**Particle Physics Division  
Mechanical Department Engineering Note**

Number: MD-ENG-031

Project: NuMI

Title: Filter and Housing Specification

Figure 1. Filter housing welded inlet transition.

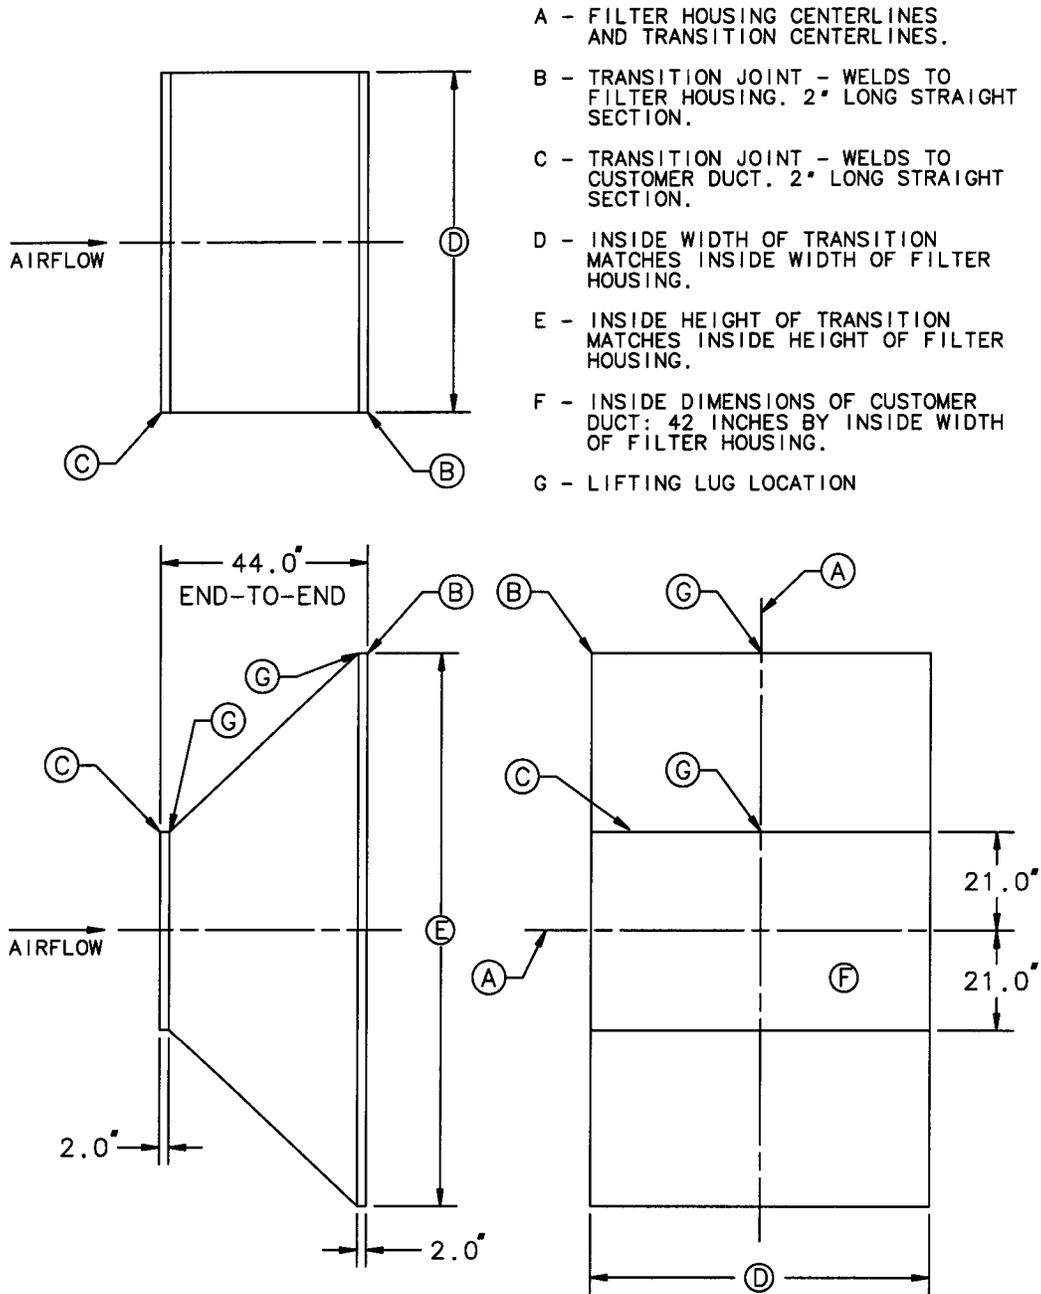
14) para 8.5 Vendor proposed 1.5" wide, turned-out flanges for the welded joint between the housing and each of the transitions. The backing strips specified in para 8.5 are not included in the proposal as they are not needed with this joint. OK.

Figure 2. Filter housing welded outlet transition.

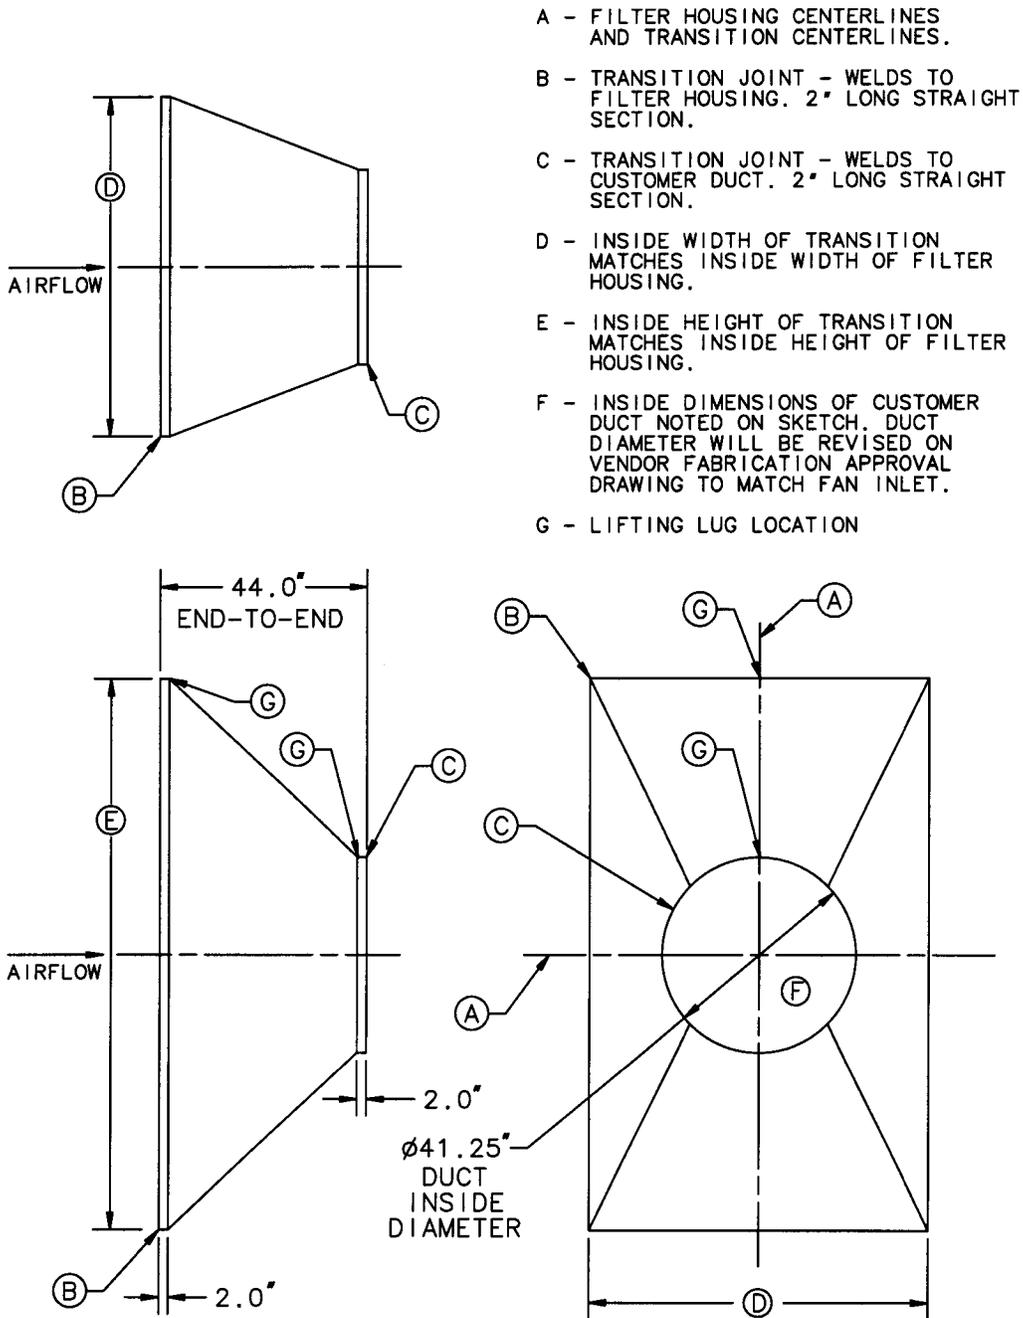
13) Figure 2. Filter housing welded outlet transition The inside diameter for the outlet duct on the outlet transition (Item "F" in Figure 2) increases from 41.25 inches to 52 inches.

- 13) Figure 2. Filter housing welded outlet transition The note on this figure states that the outlet duct diameter will be revised on the vendor fabrication approval drawing. Greg checked with the factory and told me this was ok. He quoted you a "no charge" for increasing this diameter. Let me know if you need to specify the diameter when placing the order. Otherwise, I'll note it on the fabrication approval drawing.
